**CITY OF BOULDER**  
**PLANNING BOARD AGENDA ITEM**  
**MEETING DATE: April 2, 2015**

**AGENDA TITLE:** Concept Plan (case no. LUR2015-00006) for redevelopment of an approximately 58,272 sq. ft. (1.34-acre) site located at 2440 and 2490 Junction Pl. within Boulder Junction. Referred to as “The Commons,” the proposed commercial development would consist of two, 3-4 story, 55’ tall buildings totalling roughly 100,000 sq. ft. that would include professional office space, restaurant space and “flex” space intended as community gathering space. The proposal also includes 65 underground parking spaces, a proposed “mobility hub” that includes a car share program and B-Cycle Station, a central public plaza area and multiple multi-modal connections through the site.

Project Name: The Commons  
Location: 2440 & 2490 Junction Pl.  
Size of Tract: 1.34 acres (58,272 sq. ft.)  
Zoning: Mixed Use – 4  
Comprehensive Plan: Mixed Use Business

DATE OF COMMENTS: **February 6, 2015**  
 CASE MANAGER: **Chandler Van Schaack**  
 PROJECT NAME: **The Commons**  
 LOCATION: **2490 JUNCTION PL**  
 COORDINATES: **N04W03**  
 REVIEW TYPE: **Concept Plan Review & Comment**  
 REVIEW NUMBER: **LUR2015-00

**Figure 10: Junction Place street section**

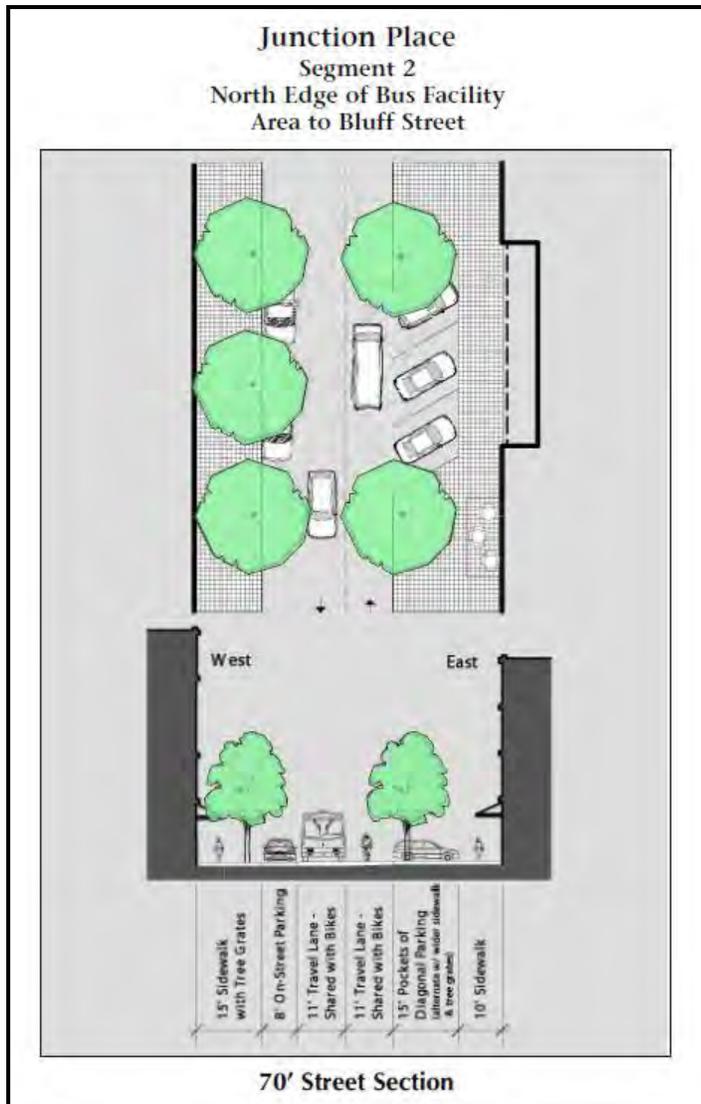
As discussed in the initial reviewer comments to the applicant (found in [Attachment C](#)), the applicant will be responsible for the dedication of right-of-way and constructing the following public improvements:

As shown in **Figure 10**, the Junction Place street section must include the following cross-sectional design elements:
